# SERVICE INFORMATION LETTER

**Subject:** Center Shaft with damaged edge preventing proper installation.

Service Information Letter No: 130513-001  
Page 1 of 3

**Figure 1**, Wencor Center Shaft with Damaged Edge

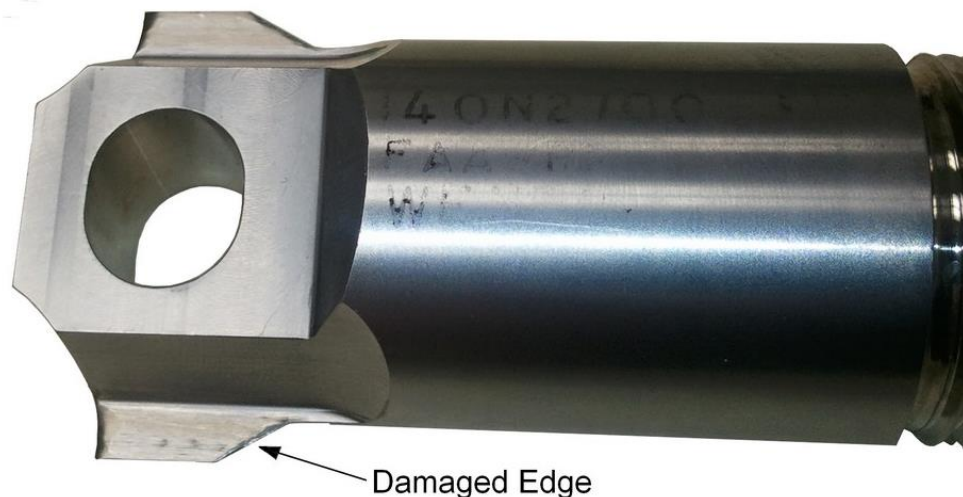
During installation of the Wencor Center Shaft PN 140N2700-5WA, a single customer discovered that an edge was slightly damaged as shown in Figure 1 below, and the damage prevented proper assembly into the NHA.

Any Wencor Center Shaft that is currently uninstalled that has the condition described in this SIL should be returned to Wencor for replacement.

However, any Wencor Center Shaft that is currently installed and in-service that have the condition described in the SIL may remain in service at the discretion of the end user without any change in aircraft safety.

**Figure 2, Exploded View of Center Shaft Installation**

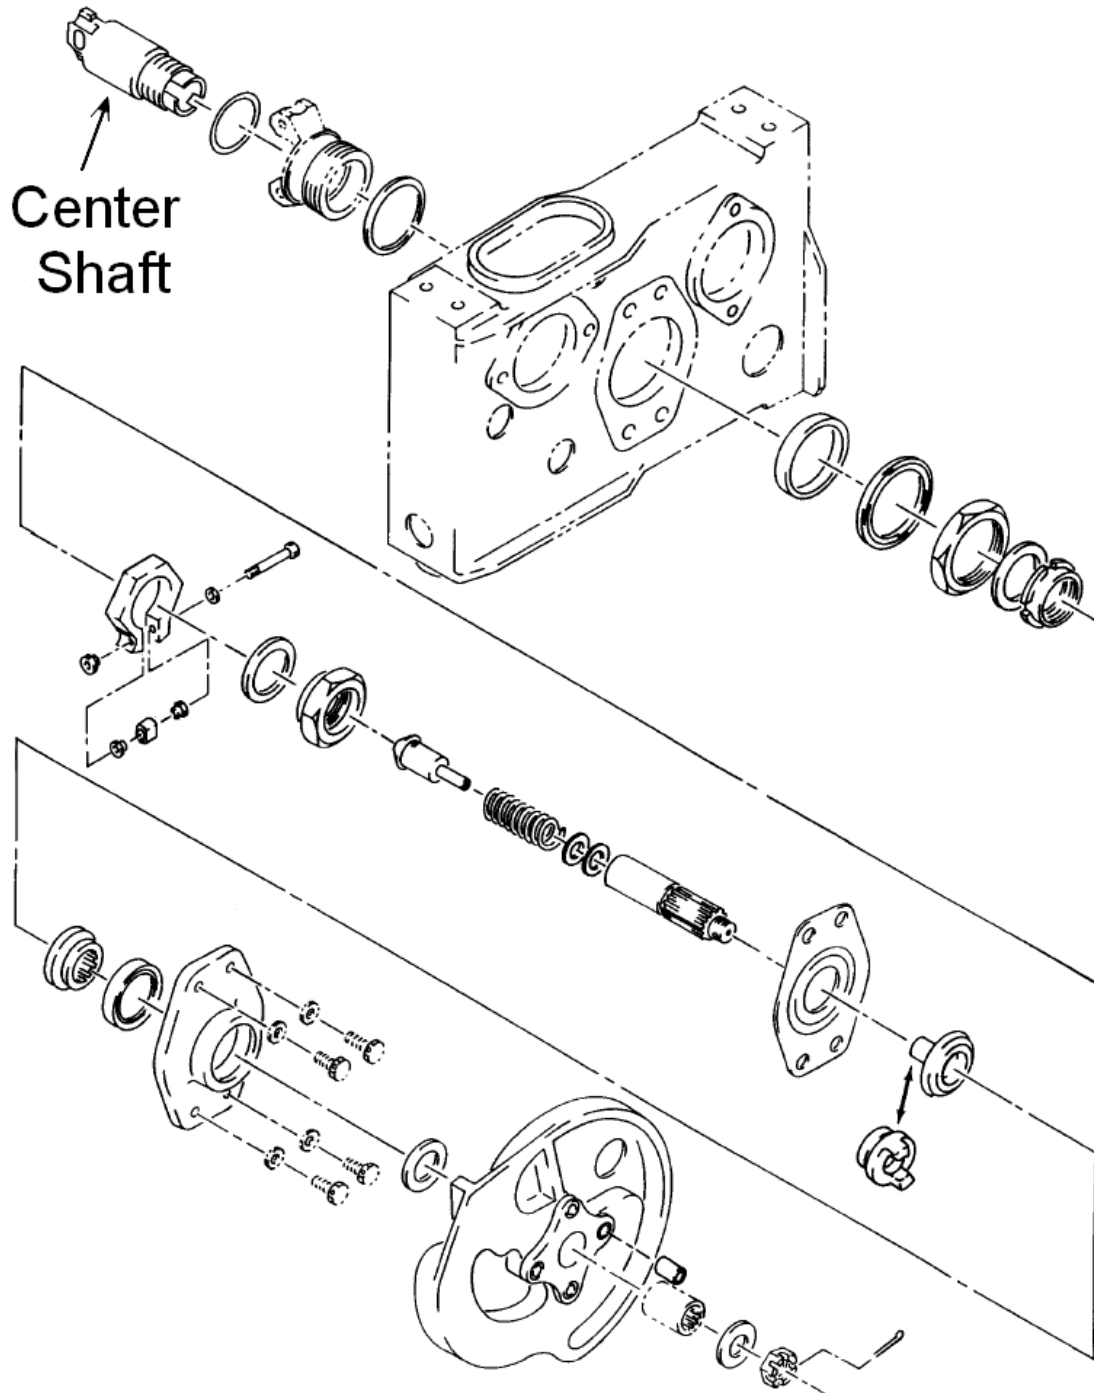
The source or cause of the damaged edge has not been conclusively determined, however the only effect of the damaged edge is displaced material that causes an interference with the mating features on the NHA (see Figure 2 below) thus preventing proper installation.
